No	Revision	Item	Date
		SCOTT C. ANDERSON & associates architects 4419 4th st ne, suite b albuquerque, nm 87107 scott@scacarchitects.com 505-401-7575	
RIO GRANDE APARTMENTS 2211 RIO GRANDE BLVD NW ALBUQUERQUE, NM 87104			
DRAWING TITLE			
<h1>SITE PLAN</h1>			
SEAL	DESIGNED	PROJECT NO	
	DRAWN	SCALE	
	CHECKED	DRAWING NO	
	REVIEWED	<h1>A-100</h1>	
	DATE 9/13/2022

SITE PLAN

Re: Rio Grande Apartments
2211 Rio Grande Blvd. NW
Traffic Circulation Layout
Architect's Stamp 09-13-22 (H12-D024)

Based upon the information provided in your submittal received 09-19-22, the above referenced plan cannot be approved for Building Permit until the following comments are addressed:

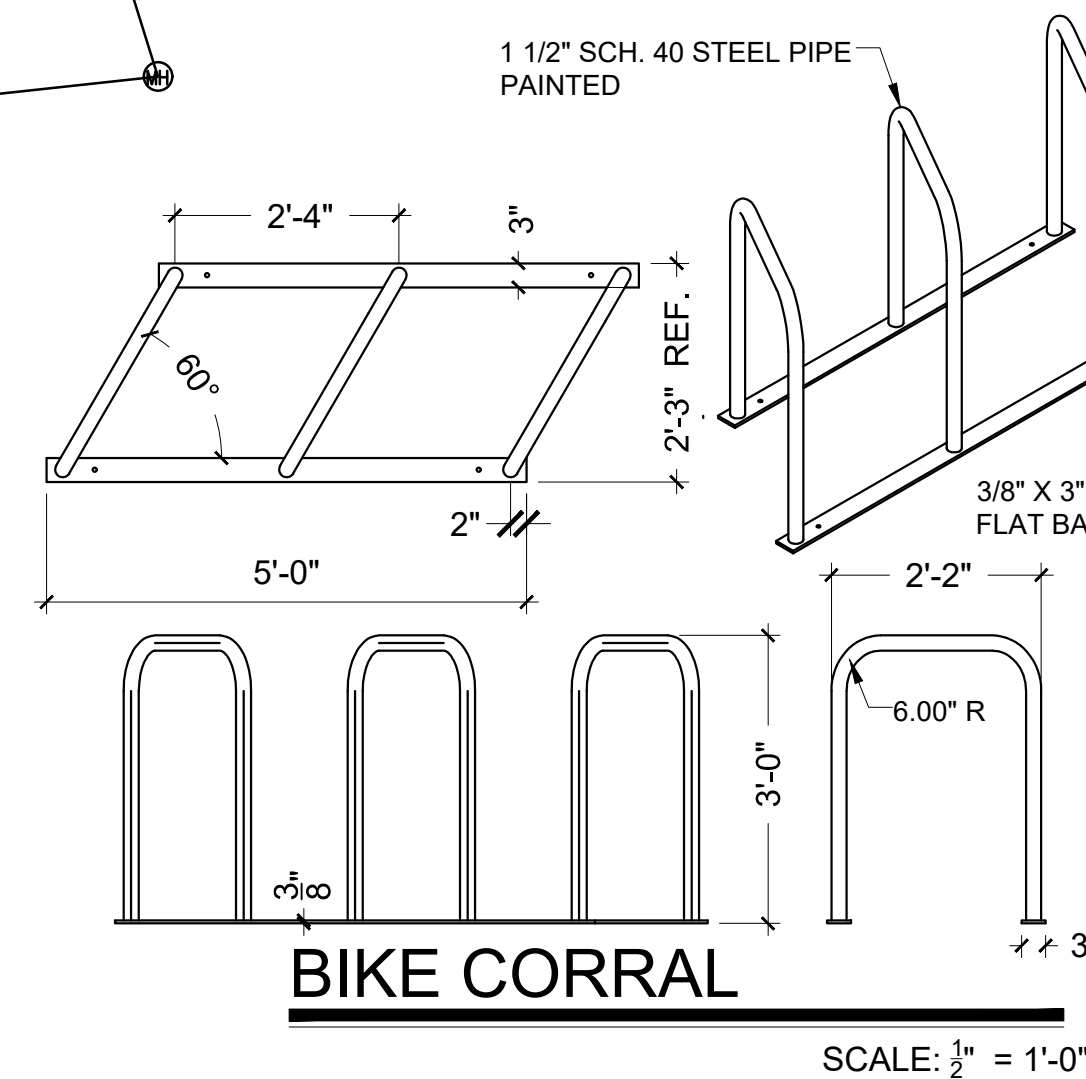
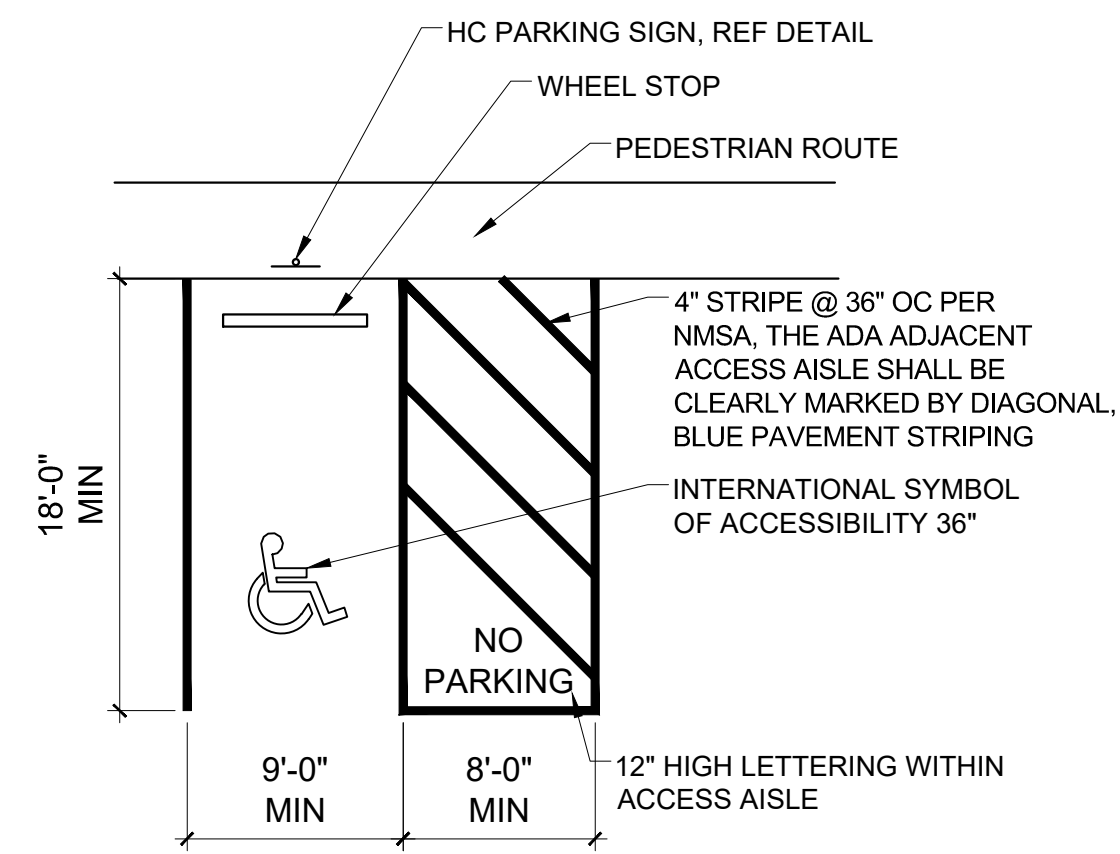
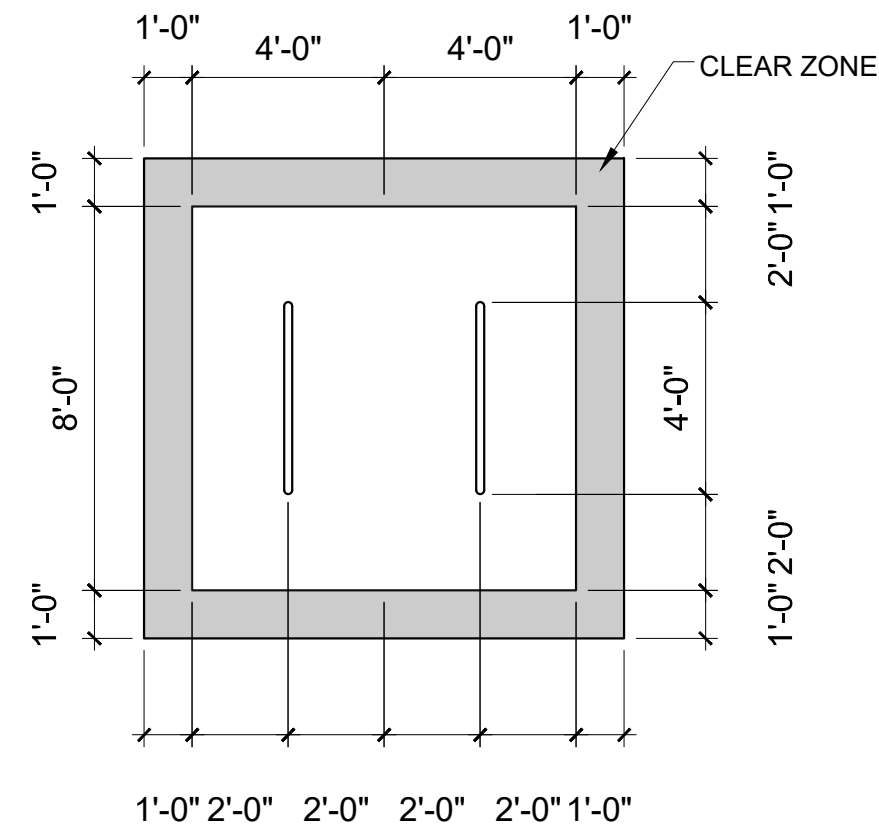
1. Per City requirement, please provide 50 ft. access throat length. See attached table 7.4.81
2. Due to proposing a gate (keynote AF), Please show Turning movement Template on the site plan.

3. Label the compact parking spaces by placing the words "**COMPACT**" on the pavement of each space. For the parking spaces at the southeast of the site.

4. Sheet A-501 is missing.
5. The ADA accessible parking sign must have the required language per 66-7-352.4C NMSA 1978 "**Violators Are Subject to a Fine and/or Towing.**" Please call out detail and location of signs.

6. ADA curb ramp at the corner of Rio Grande and Los Anayas Rd must be updated to current standards and have truncated domes installed.
7. Motorcycle parking spaces shall be designated by its own conspicuously posted upright sign, either free-standing or wall mounted per the zoning code.

8. The pavement marking "MC" should be shown in the opposite direction for Motorcycles entering the parking space.
9. A 5 ft. keyway is required for dead-end parking aisles at the south side of the site.

10. Per DPM, a 6 ft. wide ADA accessible pedestrian pathway is required from the ADA parking stall access aisles to the building entrances. Please clearly show this pathway and provide details.

11. ADA accessible pedestrian pathway should not be placed behind parking space or adjacent to a vehicular way. Vehicle and pedestrian/wheel chair conflicts should be avoided as much as possible.

12. All sidewalks along streets should be placed at the property line.

13. Parking areas shall have barriers to prevent vehicles from extending over public sidewalk, public right-of-way, or abutting lots.
14. Refuse vehicle maneuvering shall be contained on-site. The refuse vehicle shall not back into the public right of way.; provide a copy of refuse approval.

15. Provide a copy of Fire Marshal approval.
16. It is not apparent what type of pavement surface is being proposed. A hard driving surface will be required as part of this proposed project for parking area and drive aisles.

17. Please specify the City Standard Drawing Number when applicable.
18. Unused curb cuts must be replaced with sidewalk and curb & gutter. A build note must be provided referring to the appropriate City Standard drawing.
